Terex Utilities

SAFETY NOTICE

SN729

SUBJECT: Replacement Basket Bracket

Figure 1. Compatible Components - Original basket bracket and original basket bracket retaining pins
In production from 7/21/2014 through 7/30/2020

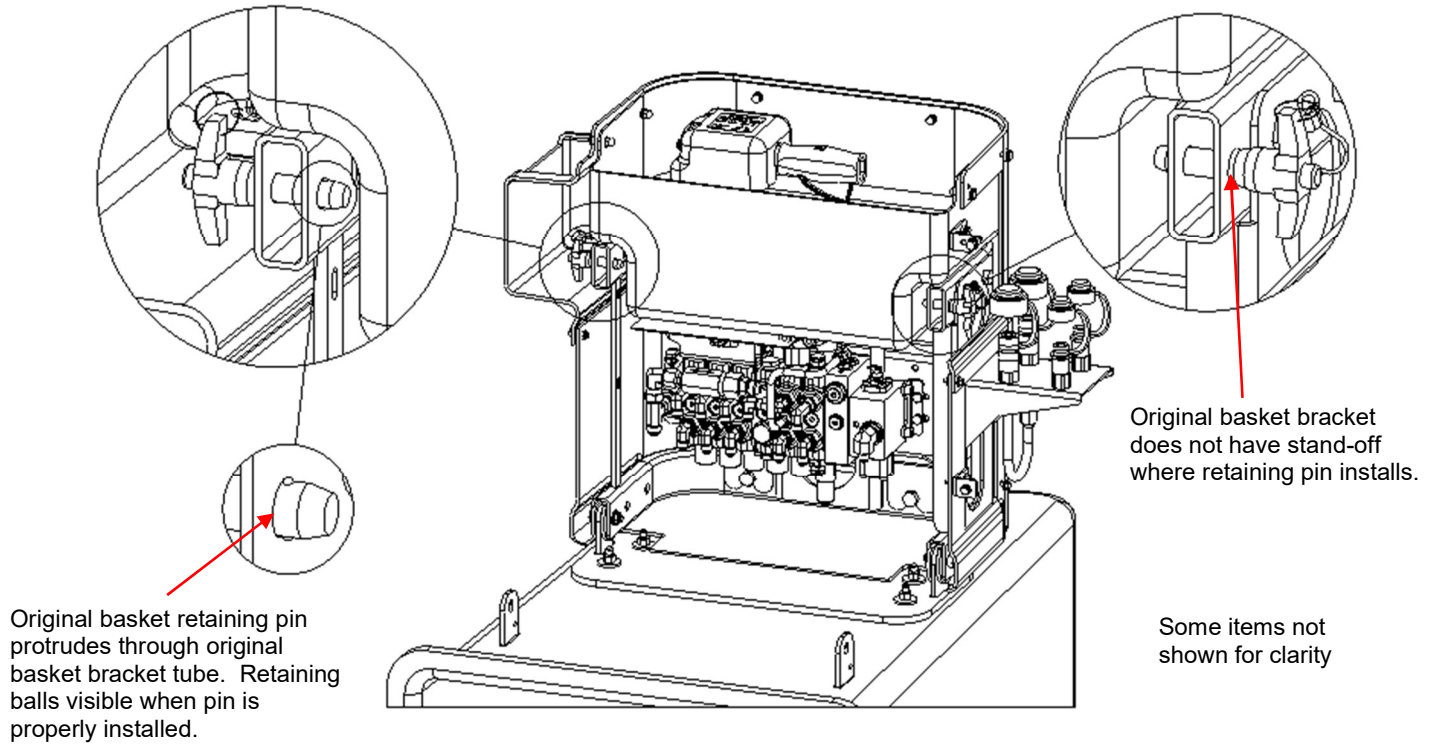
The new style replacement basket brackets as noted above may not be compatible with the original basket retaining pins on models manufactured prior to August 2020. **If both basket retaining pins disengage, the basket may tilt which can cause personal injury to the occupants of the basket.**

1. Immediately inform all users, operators, and supervisors of the contents of this bulletin.
2. Before the next use of the aerial device, inspect for compatibility of the basket bracket and the basket retaining pins using Figures 1 through 4 at the end of this bulletin as reference. Each basket retaining pin must extend through the basket bracket tube and the pin must have a method of retainment when the pin is fully installed such as retaining balls or secondary locking pins.

Terex will provide Field Service Kit Z1724, parts and labor, at no cost to the purchaser of the replacement brackets. The Field Service Kit Z1724 provides basket retaining pins and hardware to replace the original basket retaining pins.
